APPLICATION NO: 17/02460/FUL		OFFICER: Miss Michelle Payne
DATE REGISTERED: 19th December 2017		DATE OF EXPIRY: 20th March 2018 (extended by agreement with the applicant until 31st July 2018)
WARD: St Marks		PARISH: n/a
APPLICANT:	New Dawn Homes Ltd	
AGENT:	n/a	
LOCATION:	Playing Field adjacent to 10 Stone Crescent, Cheltenham	
PROPOSAL:	Erection of 13no. dwellings with associated road and sewers

RECOMMENDATION: Refuse

Figure 1 - LiDAR and Flow Accumulation

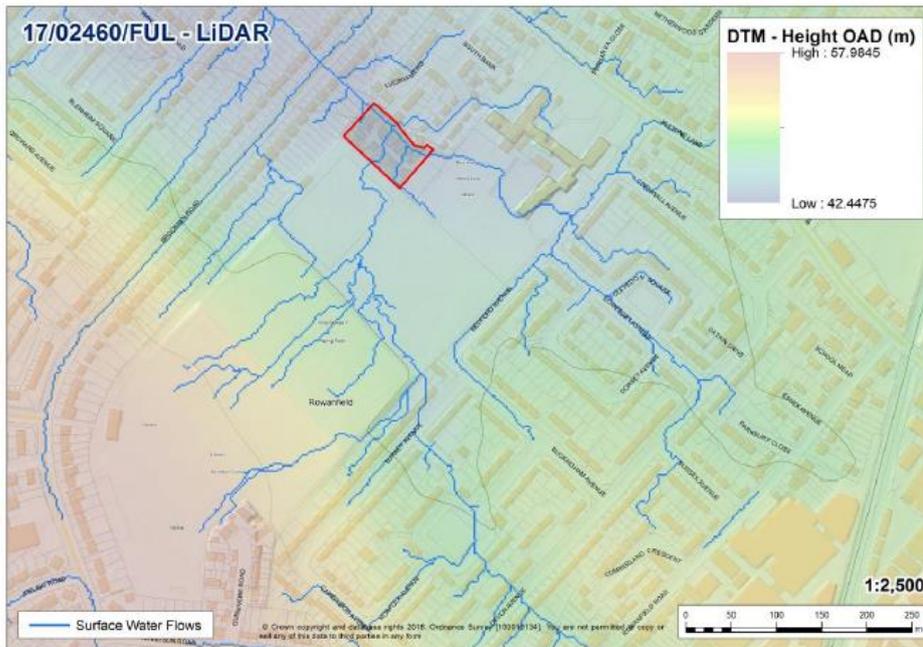
The applicant's Flood Risk Assessment (FRA) does not define/specify the level of surface water risk posed to this site. However, the FRA has stated with anecdotal evidence that land features and ground characteristics in the surrounding fields prevent surface water flows from reaching the site and being a source of flood risk to the proposed development. The applicant has also suggested the properties are positioned in the least at-risk locations, and a cut-off drain may be installed to manage the surface water from the fields.

Although it has been stated by the applicant that the soil from the adjacent fields lends itself to allow for infiltration, any surface during rainfall events (e.g. 1% or 3.33% Annual Exceedance Percentage (AEP)) will almost certainly generate runoff. The characteristics of the field will determine rate and quantity of runoff that will be generated. In addition to this, LiDAR clearly shows the development site to be the lowest point of the greater greenspace where surface flows will naturally drain to. A flow accumulation assessment carried out by the LLFA on the LiDAR confirms these flows do drain through the development site, see Figure 1.

Figure 2 – Environment Agency Surface Water Flood Maps

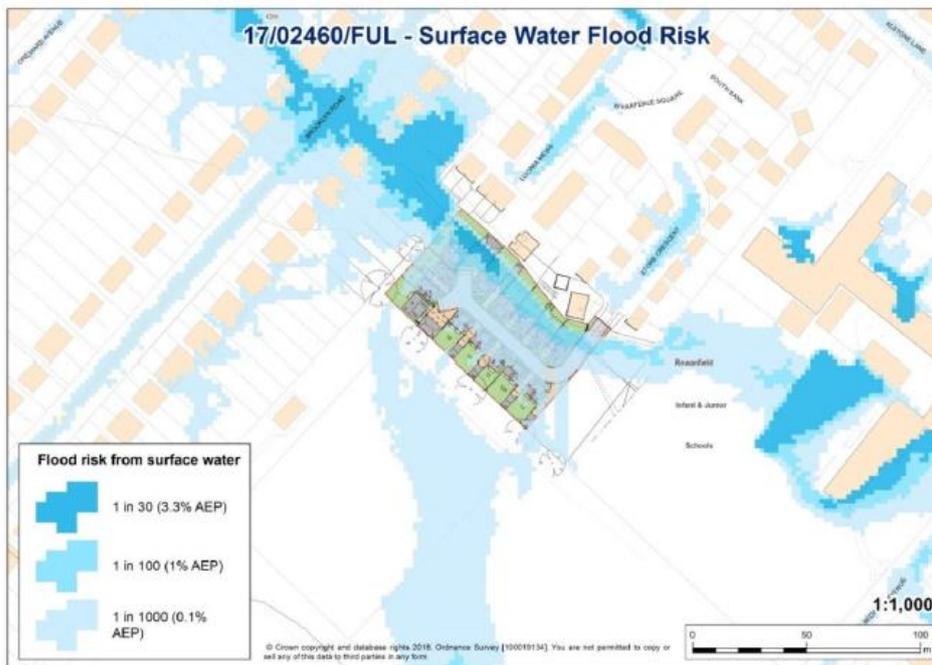
This is reflected in the Environment Agency’s surface water flood risk mapping, see figure 2, which show surface water flows travelling directly through the proposed site, in particular during a 3.33% AEP event (also known as the 1 in 30 year event) and the 1% AEP event. Also of note, the site is predominately within the 0.1% AEP extent (i.e. 1 in 1000 year flood extent).

As recommended by BS8533:2017 (Assessing and Managing flood risk in development. Code of practice), surface water flows that could enter the site from elsewhere should be realised and considered to ensure surface water does not pose a flood risk to development. The LLFA acknowledges the applicant has stated a cut-off drain could be installed; however its hydraulic performance and ability to manage the surface water flows has not been explored nor stated (i.e the adequacy of the cut-off drain to capture the runoff that would drain to the site from the adjacent fields). Therefore, the FRA has not assessed the

surface water flow from the adjacent fields sufficiently to convince the LLFA that these properties will not be at risk of flooding from surface water in accordance with the requirements of the NPPF. On this basis the LLFA does not support the principle of the development that is currently being presented.
